Overview of ENERGY STAR

Single-Family New Homes Rev. 12

Multifamily New Construction Rev. 03

2022 Residential New Construction Partner Meeting

#4. Slab thermal bridging clarifications

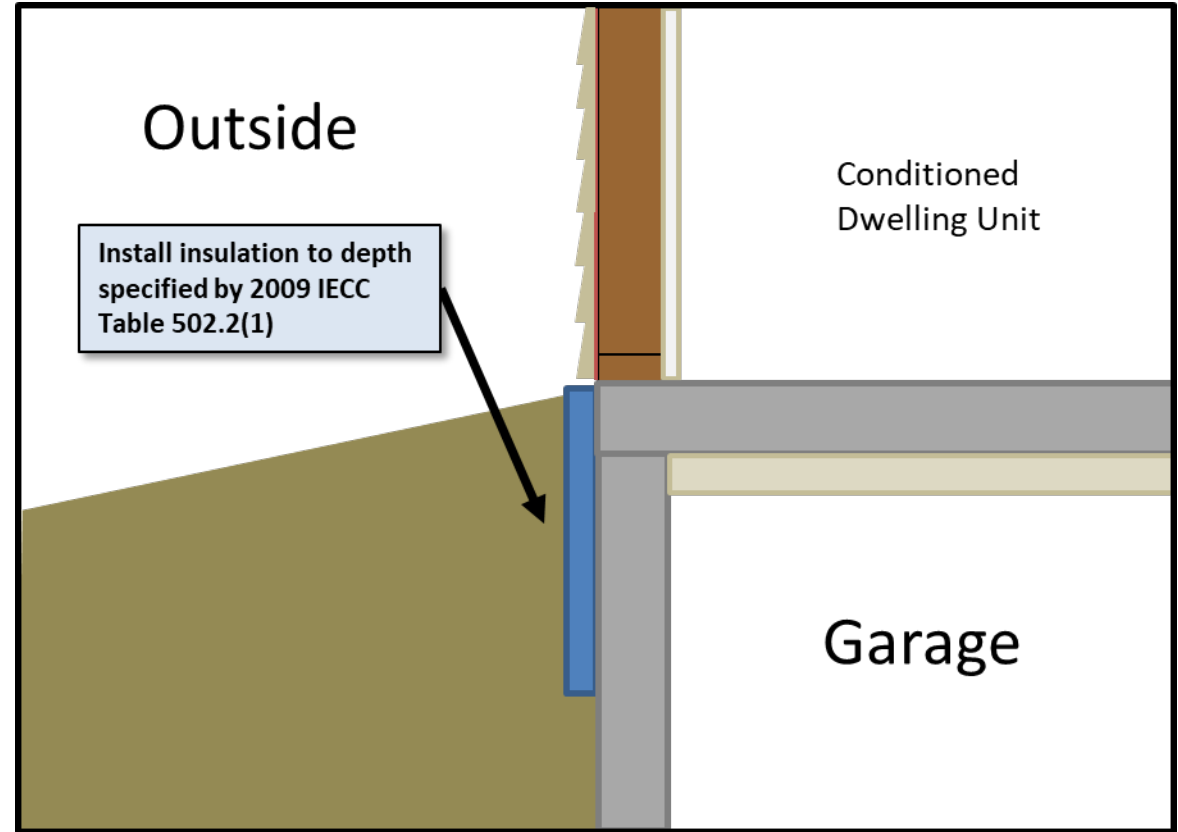
- 3.3 Insulation beneath attic platforms (e.g., HVAC platforms, walkways) $\geq R-21$ in CZ 1-5; $\geq R-30$ in CZ 6-8. ¹⁰
- 3.4 For slabs on grade or at grade without ground contact in CZ 4-8, 100% of slab edge insulated to $\geq R-5$ at the depth specified by 2009 IECC Table 502.2(1) & aligned with the thermal boundary of the walls. ^{10, 21, 22}

- 3.5 For above-grade concrete slab edges (e.g., podiums, balconies) in CZ 4-8, 100% of slab edge insulated to $\geq R-5$ & aligned with the thermal boundary of the walls. At this boundary, for slabs resting on mass walls, insulation must extend ≥ 8 ft. below the bottom of the slab edge & for slabs resting on columns, the insulation must surround the column, at a depth of 4ft. Alternatives in Footnote 24. ^{10, 23}

- 3.6 For concrete slab floors in CZ 4-8 above ambient conditions, garages, or unconditioned spaces outside the thermal boundary, floor insulation meets the U-factor specified in Table 502.1.2 of the 2009 IECC for Group R when dwelling units are above the slab, & 'All Other' when common space is above the slab. ^{10, 25}

#4. Slab thermal bridging clarifications (Item 3.4, con't)

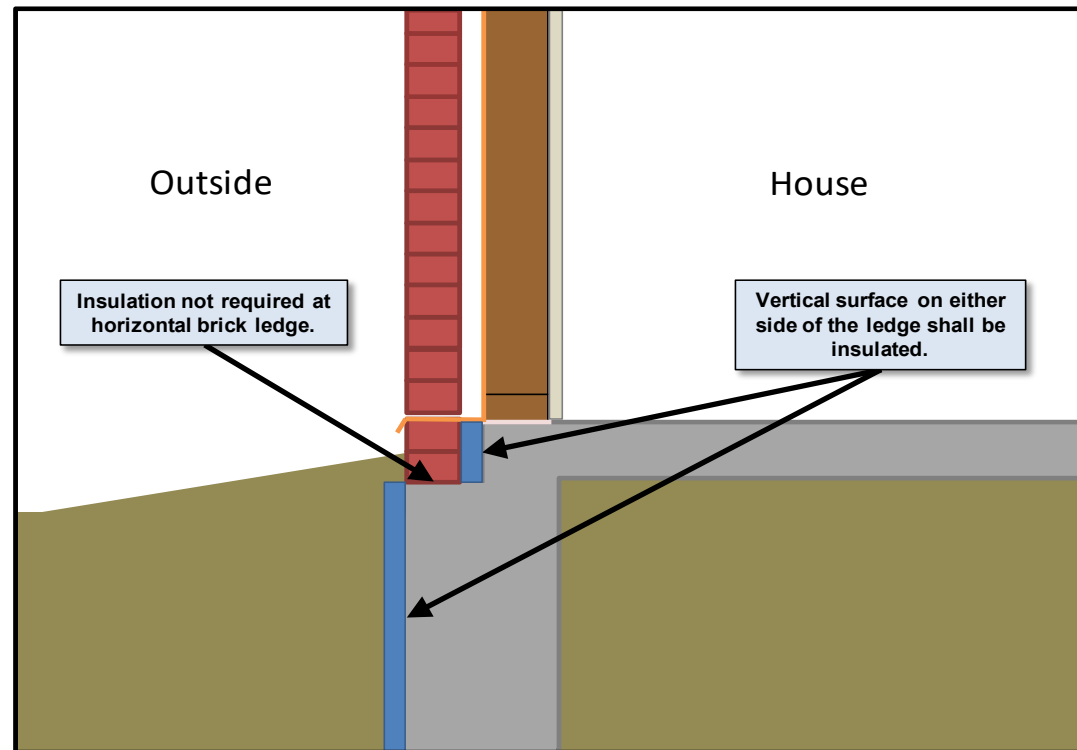
- Slabs with **multiple pours** may use the monolithic slab detail if all concrete is in direct contact and reinforced (e.g., with rebar) at the joints.

#4. Slab thermal bridging clarifications (Item 3.5, con't)

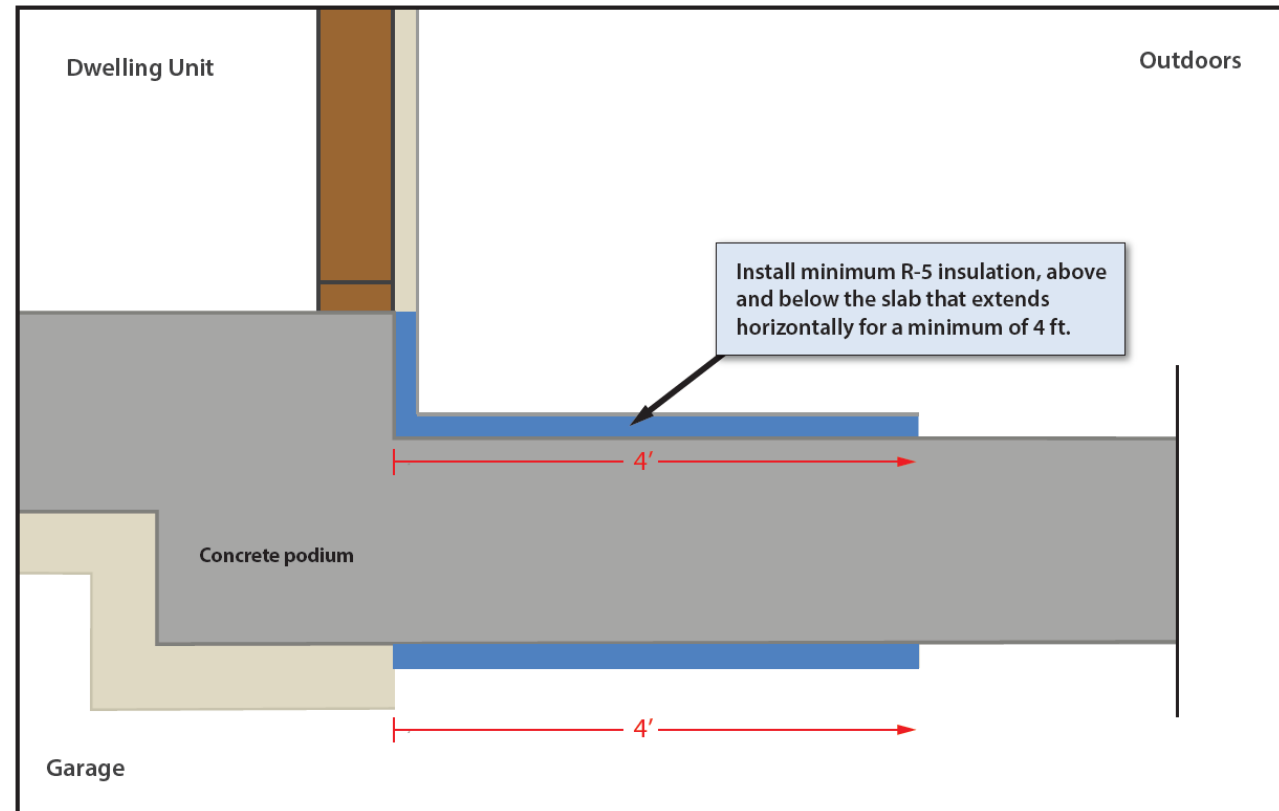
- New alternative- horizontal insulation for projected slabs without a thermal break

#4. Slab thermal bridging clarifications (Item 3.5, con't)

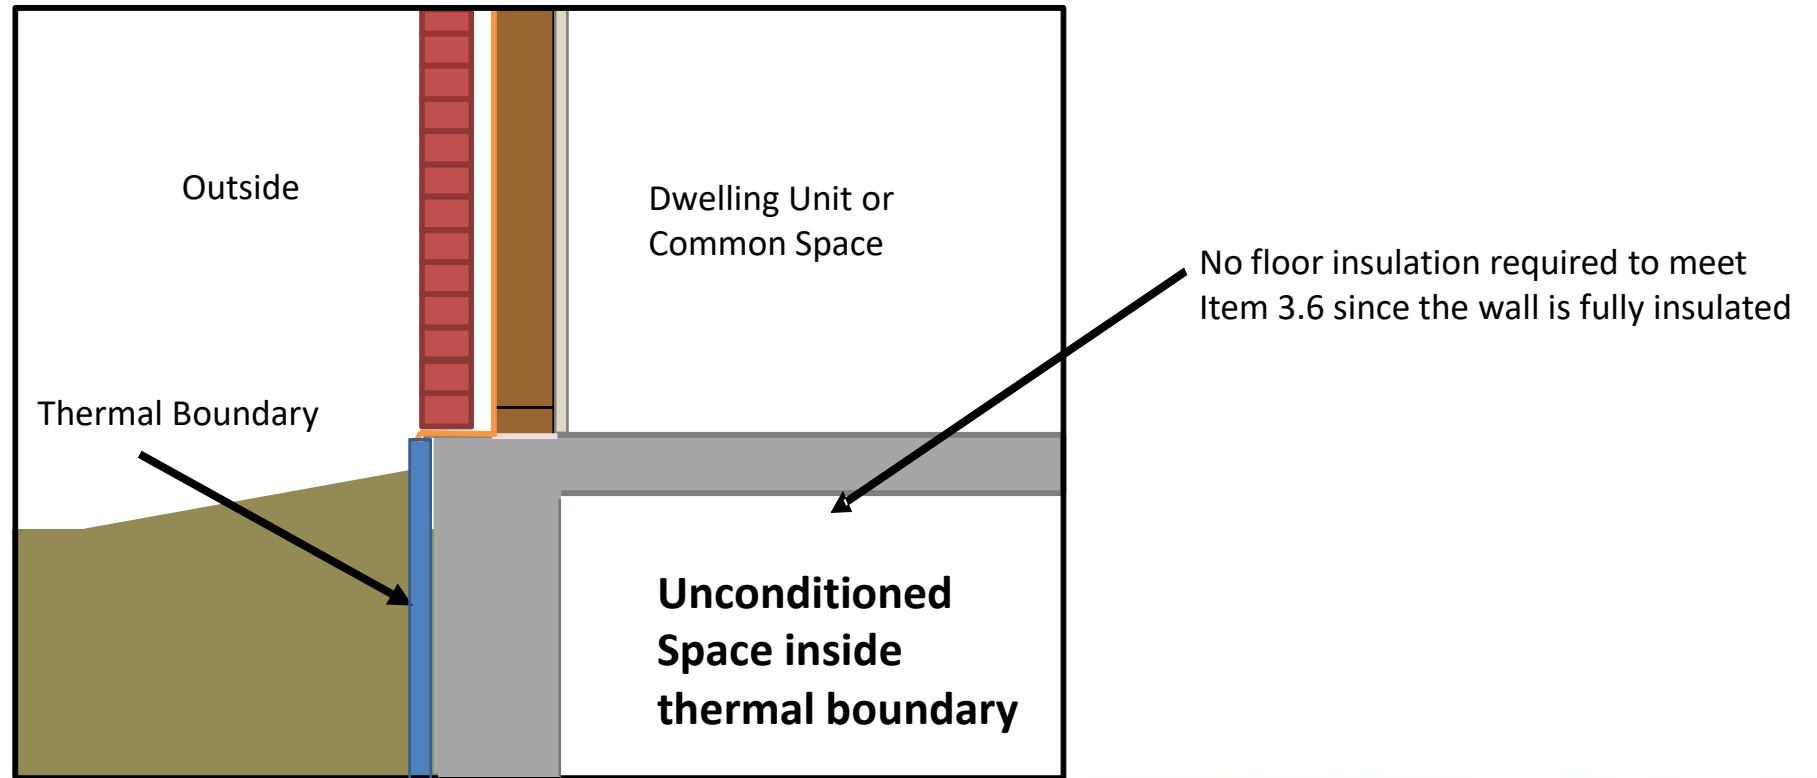
- Reorganized Footnote 24 to include alternatives

For projected slabs (e.g., podiums, balconies), where a minimum of R-5 slab edge insulation is not installed between conditioned space and the unconditioned projected slab, use one of the options below:

- a) Modify the UA calculation for the wall assembly that accounts for this projected slab when demonstrating compliance with Item 1.2.
 - a. Where no insulation is installed, modify the UA calculation such that the area of the wall that is uninsulated due to the projected slab is calculated as 400% of that actual area. For example, for a projected slab without any thermal break that is 20 feet wide, and has a thickness of 1 foot, the area to be used in the UA calculation is 80 ft² instead of 20 ft².

- b. Where insulation R-2 and greater is installed, the area is not required to be modified.
- b) Install minimum R-5 insulation, above and below the slab that extends horizontally for a minimum of 4 ft. Insulation installed on top of slab shall be covered by a durable floor surface. When demonstrating compliance with Item 1.2, R-1 insulation may be associated with the area of the wall that is uninsulated due to the projected slab.

#4. Slab thermal bridging clarifications (Item 3.6, con't)

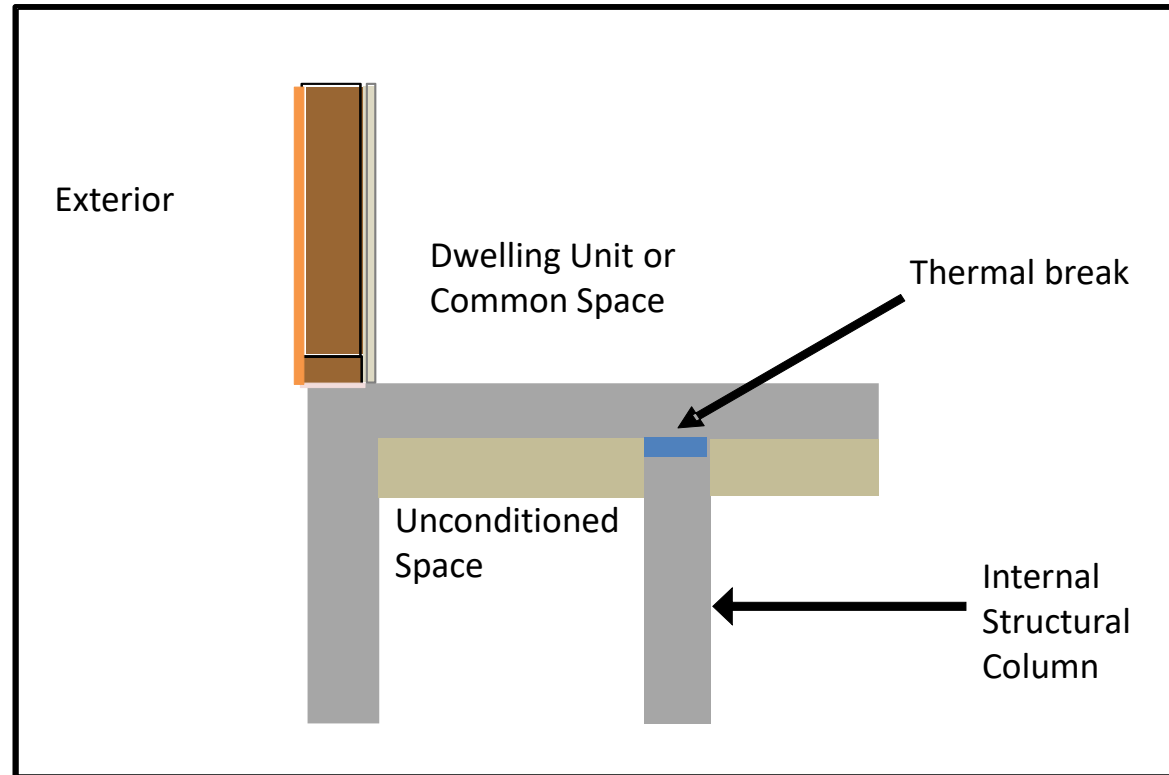
- For structural columns with a thermal break supporting concrete slabs (e.g., podiums), no de-rate penalty on the floor UA is required

#4. Slab thermal bridging clarifications (Item 3.6, con't)

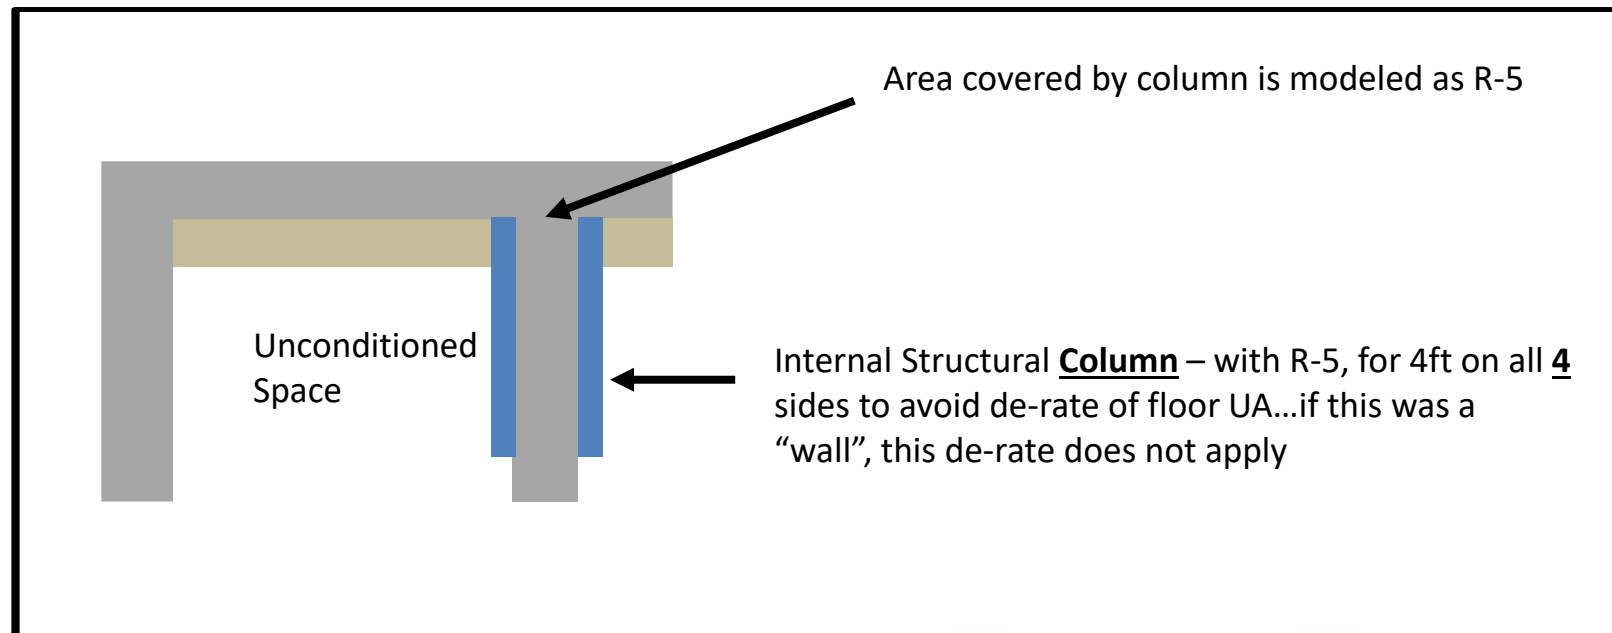
- For structural columns without a thermal break, the de-rate only applies to structural 'columns', not 'walls'.
- Also, where using the insulated column alternative, a maximum of R-5 can be used in the modified floor UA calculation

#4. Slab thermal bridging clarifications (Item 1.5.2)

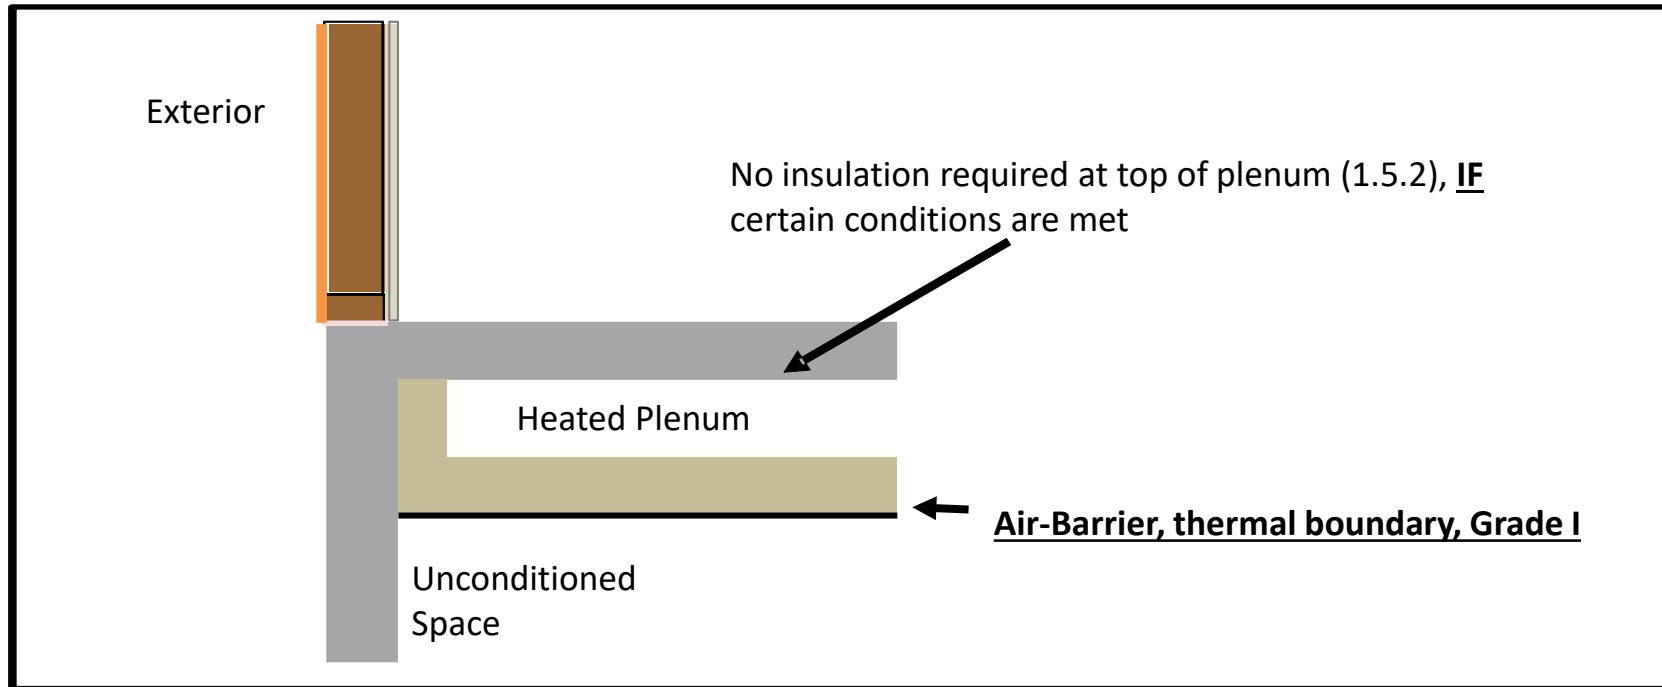
- For heated plenums, new alternative where just the bottom of the plenum can be insulated instead of both top and bottom
